Project	IEEE 802.16 Broadband Wireless Access Working Group < http://ieee802.org/16 >	
Title	Changes in 802.16e Working Document for SS Authorization via EAP framework	
Date	2003-10-31	
Submitted		
Source(s)	Ae Soon Park Seokheon Cho Sun Hwa Lim Young Jin Kim Jee Hwan Ahn ETRI 161 Kajong Dong, Yuseong Gu, Daejon, Korea.	Voice : +82-42-860-5172 Fax: +82-42-860-5471 mailto: aspark@etri.re.kr chosh@etri.re.kr shlim@etri.re.kr
Re:	This is a response to a Call for Comments IEEE 802.16e-03/23 on IEEE 802.16e-03/07r4	
Abstract	This document contains suggestions on the additions in IEEE 802.16e-03/07r4 that would help user authorization in EAP-TLS procedure.	
Purpose	The document is submitted for review by Handoff/Sleep mode Ad Hoc Group and/or by 802.16 Working Group members	
Notice	This document has been prepared to assist IEEE 802.16. It is offered as a basis for discussion and is not binding on the contributing individual(s) or organization(s). The material in this document is subject to change in form and content after further study. The contributor(s) reserve(s) the right to add, amend or withdraw material contained herein.

Changes in 802.16e Working Document for SS Authorization vi

Figure 97-b Authorization state machine flow diagram (open policy)

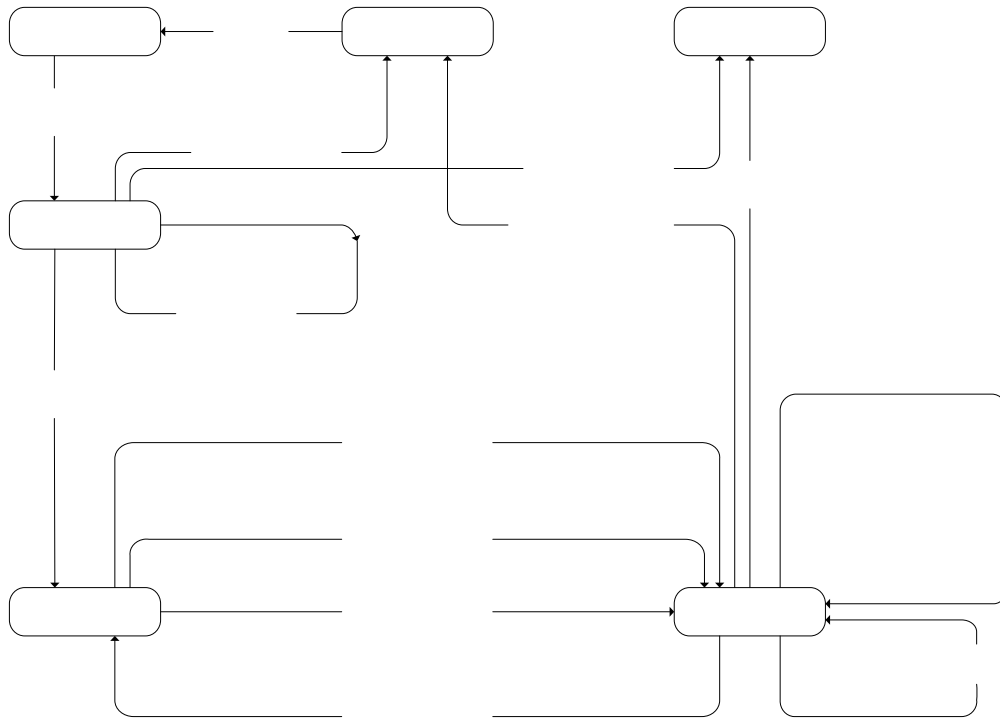
[Add Under Figure 97]

Figure 99—AK management in BS and SS

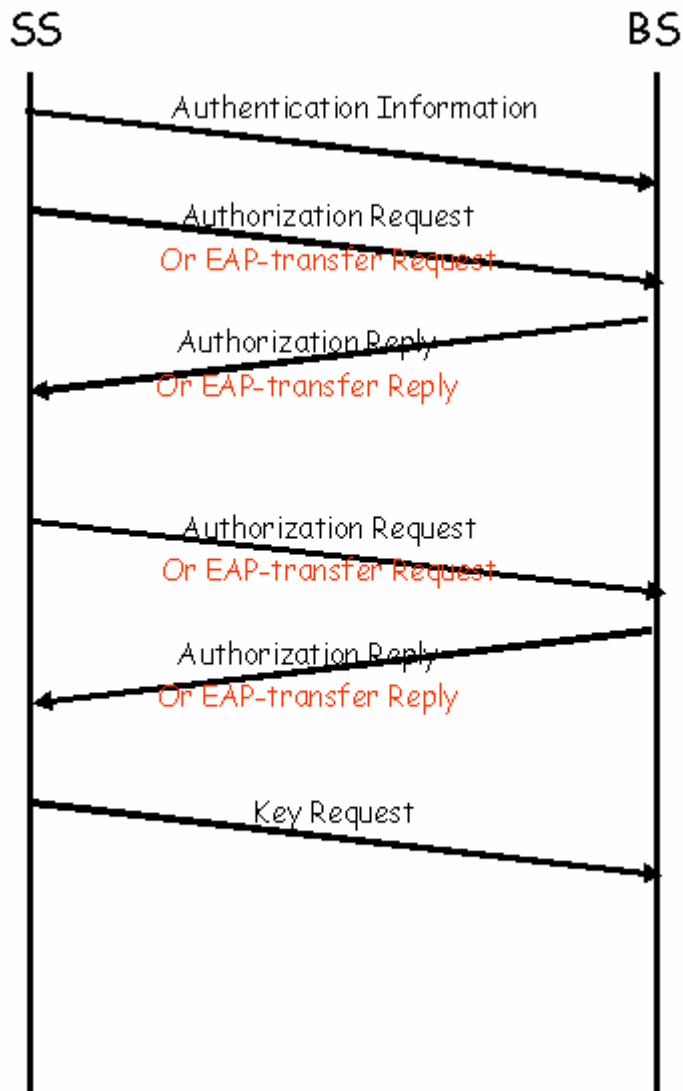
Figure 99 Modified
